Date: November 13, 2002  
 To: T10 Technical Committee  
 From: Alvin Cox (alvin.cox@seagate.com)  
 Subject: SAS Test Loads

The following changes to text and test load figure are made to aid the testing process by clarifying and defining the compliance interconnect test load and zero-length test load. The changes to the rev 0 version are significant and not highlighted in an effort to make this version more readable. Revision 2 adds a statement explaining the purpose of compliance interconnect testing. Revision 3 adds additional changes to section 5.7 as agreed upon during the face-to-face 11/4-11/5. Revision 4 updates document number to match T10 voting minutes (no technical changes).

**Figure 39 — Transmitter test loads**

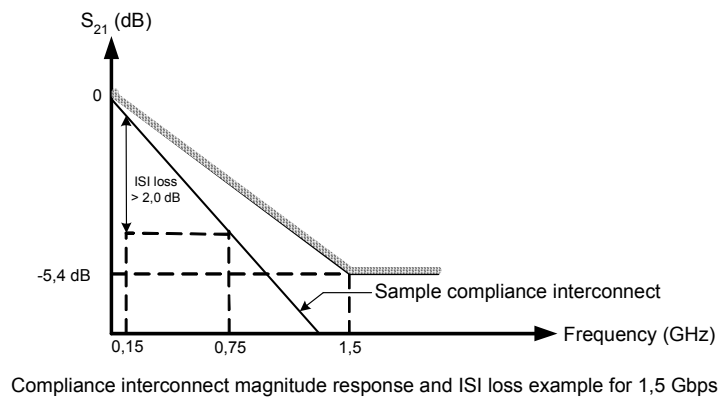
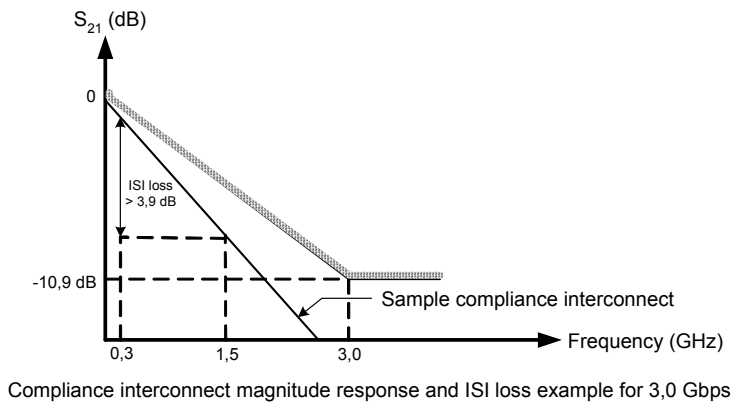
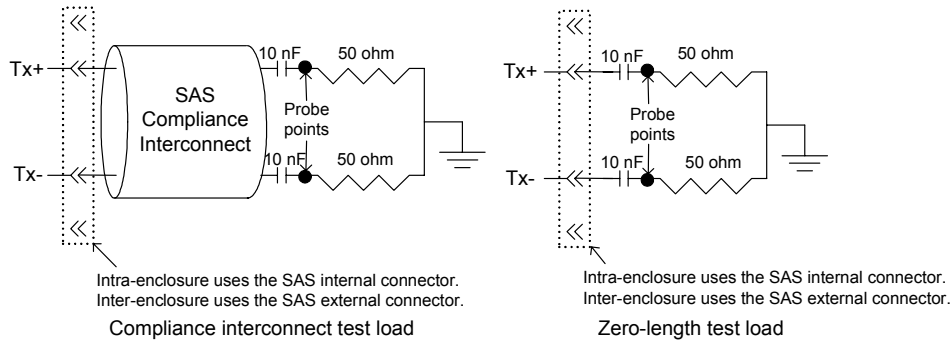
Compliance with the TCTF test load requirement shall be determined either (a) by measuring the signal produced by the transmitter through a physical compliance interconnect attached to the transmitter or (b) by mathematically processing through the TCTF the signal captured using a zero-length test load.

Compliance with the zero-length test load requirement shall be determined by measurement made across a load equivalent to the zero-length load shown in figure 39.

The compliance interconnect magnitude response and ISI loss examples for 3 Gbps and 1,5 Gbps are shown in figure 39.

A combination of a zero-length test load and the transmitter compliance transfer function (TCTF) test load methodology is used for the specification of the initiator, expander or target device transmitter characteristics. This methodology specifies the transmitter signal at the test points on the required test loads. The transmitter shall use the same settings (pre-emphasis, voltage swing, etc.) with both the zero-length test load and the TCTF test load. The received signal specifications shall be met under each of these loading conditions.

The TCTF is the mathematical statement of the transfer function through which the transmitter shall be capable of producing acceptable signals as defined by a receive mask. The transmission magnitude response,  $[S_{21}]$ , of the TCTF in dB satisfies the following equation:

$$|S_{21}| \leq -20 \log(e) \{ [6.5 \times 10^{-6} (f^{0.5})] + [2.0 \times 10^{-10} (f)] + [3.3 \times 10^{-20} (f^2)] \} \text{ dB}$$

The TCTF is used to specify the requirements on transmitters that may or may not incorporate pre-emphasis or other forms of compensation. A compliance interconnect is any physical interconnect with equal or greater loss at all frequencies than that required by the TCTF.
